Title: Cavalon Engine Mounting Bolts – Out Of Phase Check Torque		
AG-SB-2019-04-A-EN		Compliance Category: A - MANDATORY B – RECOMMENDED C - OPTIONAL
Applicability		
Aircraft type & model: Cavalon 915iS	Affected Serial number(s): All Cavalon fitted with a Rotax 915iS engine up to and including serial number V00464	
The maintenance manual to be referenced is this stated or subsequent issue.		As per AutoGyro website
<p>This form is the response from AutoGyro GmbH either against a problem found in the product in service requiring a containment or rectification action, or as service information for aircraft modification incorporation. For help, contact AutoGyro on 49(0)5121 88056-00, or email airworthiness@auto-gyro.com.</p>

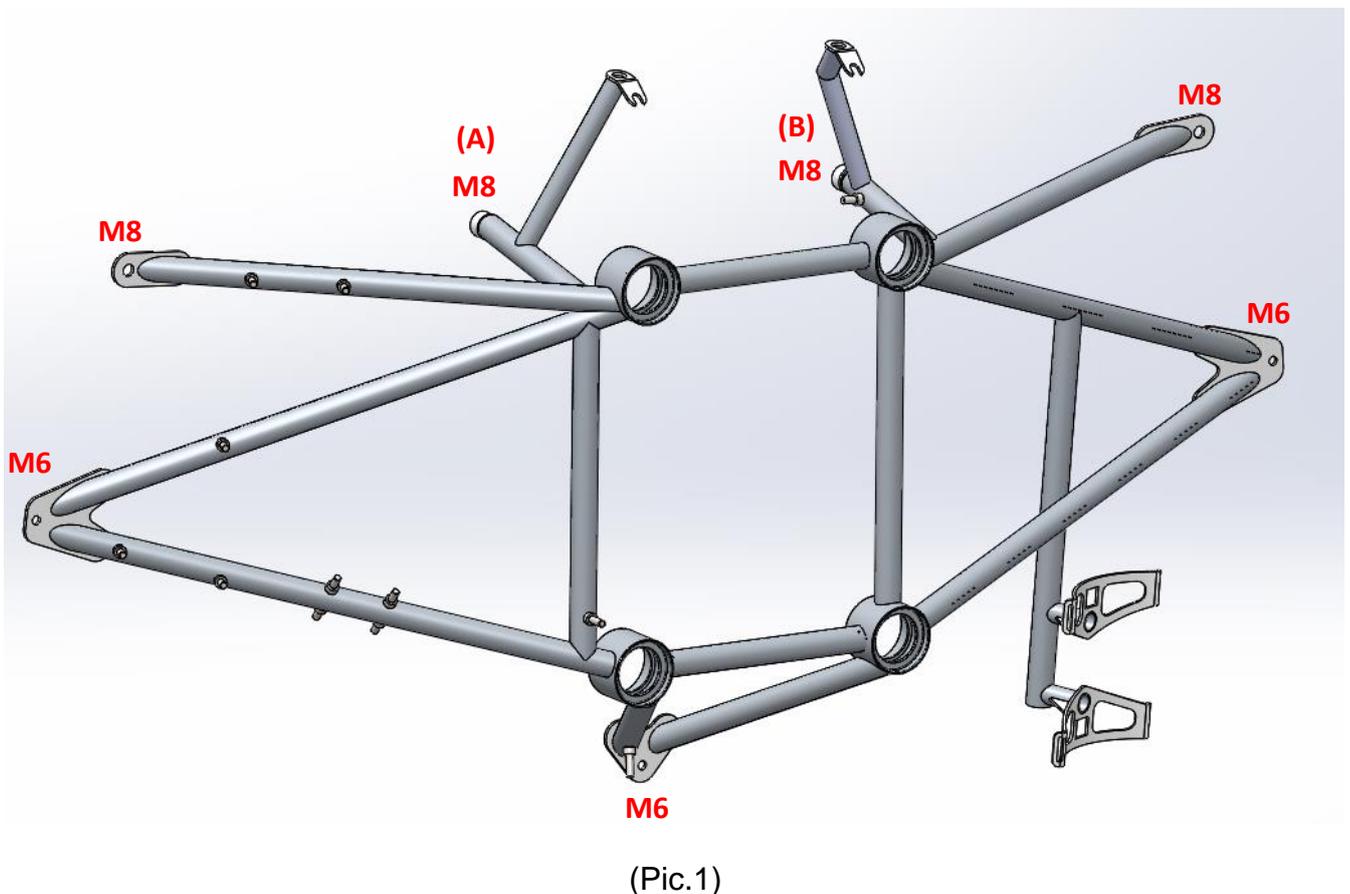
It has been found that the engine mounting frame (46764) on AutoGyro Cavalons fitted with Rotax 915iS engines may “settle” into the fire protection affixed to the engine bulkhead.

This can lead to some engine mounting bolts losing their correct torque.

This service bulletin introduces an additional, single, service inspection for a cheque torque on the engine mounting frame to bulkhead bolts **at 5 flying hrs, or within the next 5 flying hours**. Thereafter as called for in the 25 and 100 hr inspections in the service protocol “Engine and Services”, item 131.

1. Gain access to the engine mounting frame (46764) by removing the upper and lower engine cowlings in accordance with the AMM job card 52-00-00 4-1.
2. Carry out a check-torque of the 7 engine mounting bolts (pic. 1). All bolts are torqued to standard torques for the bolt size as stated in the AMM Part B 01-12-00:
 - M4: 2-3 Nm
 - M5: 5-6 Nm
 - M6: 11 +/-1 Nm
 - M8: 25 +/-3 Nm
 - M10: 35 Nm +/-4 Nm
3. Should the mounting bolts at positions (A) and (B) below be found to have lost torque, they should be individually removed, Loctite 243 applied, and re-fitted.
4. Should mounting bolts at any other position (secured by with Nyloc) be found to have lost torque, they should be tightened to the correct torques stated above in paragraph 2.
5. Re-fit the engine cowlings, ensuring the lower cowling M4 screws are re-fitted using Loctite 221.
